**LEVY NUCLEAR PLANT, UNITS 1 AND 2
DOCKET NOS. 52-029 AND 52-030
SUPPLEMENT 6 TO RESPONSE TO REQUEST FOR ADDITIONAL INFORMATION
REGARDING THE ENVIRONMENTAL REVIEW**

**Levy Nuclear Plant Units 1 and 2
Supplement 6 to Response to Request for Additional Information Regarding the
Environmental Review, dated February 24, 2009**

FLUCCS Level 3 Habitat Types
 in Vicinity of LNP Site

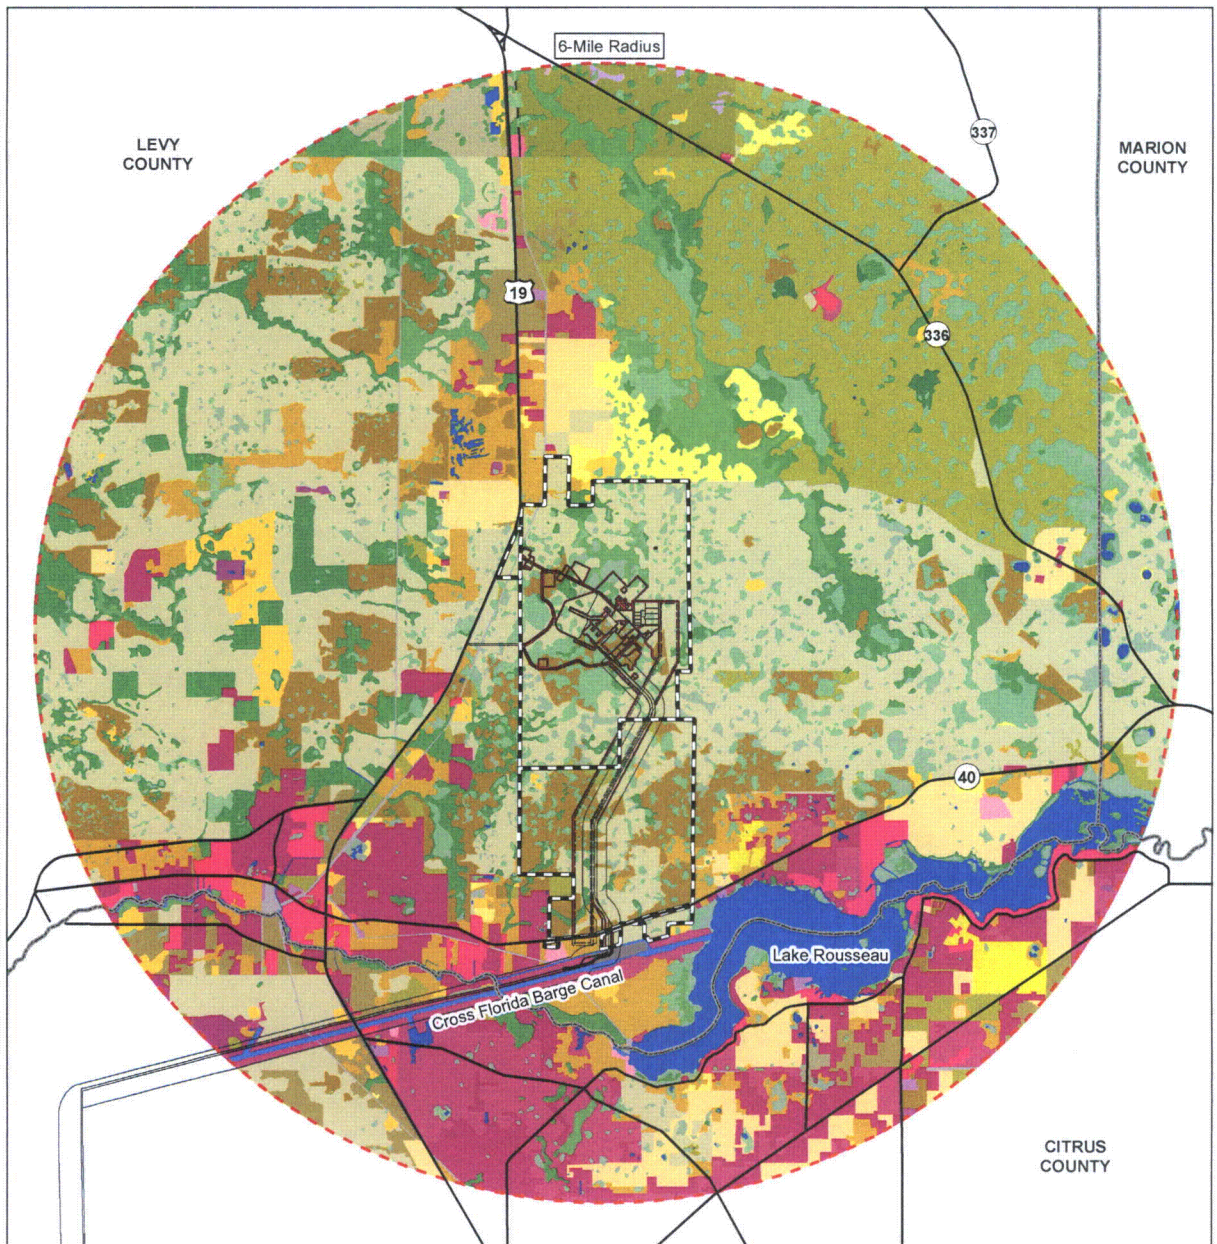
“Column 4 of Table 4.3.1-1-002 from the 6-12-09 RAI supplemental response (page 94) provides the acreage of FLUCCS cover types that lie within the LNP site vicinity (i.e., a 6-mile radius). A quick examination of the accompanying figure (001 Attachment 4.3.1-1B – FLUCCS

Habitat Types in Vicinity of LNP site) identifies substantial areas of Residential, Low Density (FLUCCS 110) and Residential, Medium Density (FLUCCS 120) cover types not accounted for in Table 4.3.1-1-002. Numerous other inconsistencies are noted between the table and figure (i.e., FLUCCS cover types in the table not shown on the figure; FLUCCS cover types shown on the figure not represented in the table). Please explain these discrepancies and provide a revised table or figure as warranted.”

The discrepancies noted in the agenda item are due to the use of different levels of FLUCCS codes in the table and figure. The table reflects Level 3 FLUCCS codes and descriptions; the figure reflects the more general codes of Level 2 FLUCCS codes. The Level 2 FLUCCS descriptions were intended to accommodate the differences in source data and present a more relevant comparison of habitat types across different Water Management Districts (WMDs). Additionally, the original request was to analyze impacts that occurred on-site and the relative abundance of those land use types. A revised table and figure are attached to this response to replace the previous table and figure using Level 3 FLUCCS codes for the table and figure for consistency. The revised table and figure are based on FLUCCS data obtained from the Suwannee River Water Management District (2004) and the Southwest Florida Water Management District (2007). The FLUCCS descriptions are based on the descriptions provided by the WMDs and may be slightly different than descriptions described by the FLUCCS Manual (Florida Department of Transportation, 1999). Any discrepancies are due to modification by the individual WMDs.

The amount of habitat potentially impacted on the LNP site was compared with the amount of similar habitat available in the vicinity (6-mile radius), and the ratio of the two was determined. Land uses (FLUCCS) within a 6-mile radius of the project site are presented in Attachment 4.3.1-1B, which replaces the previous attachment. For all major FLUCCS classifications, on-site areas of potentially impacted habitats were less than 5 percent of the similar habitat areas available in the vicinity. The majority of the habitats on-site have been disturbed by land use practices in the past. Due to the prevalence of similar habitats in the surrounding area and previous disturbance of on-site habitats, the impacts to habitats on-site should not significantly reduce the availability of those habitats in the vicinity of the LNP. This determination does not include the enhancement to a variety of habitats on and near the LNP site that are expected to result from implementation of the wetland mitigation program. A summary table is provided below.

1. Replace ER Tables 4.3-1 and 4.3-2 with the information provided in this response and the original RAI response.
2. Revise the text in ER Section 4.3 to reflect the revised FLUCCS values included in the revised tables.
3. Revise the source data on ER Figures 2.4-6 and 2.4-8 to match the source data on the revised tables.
4. Add figure shown as Attachment 4.3.1-1B.
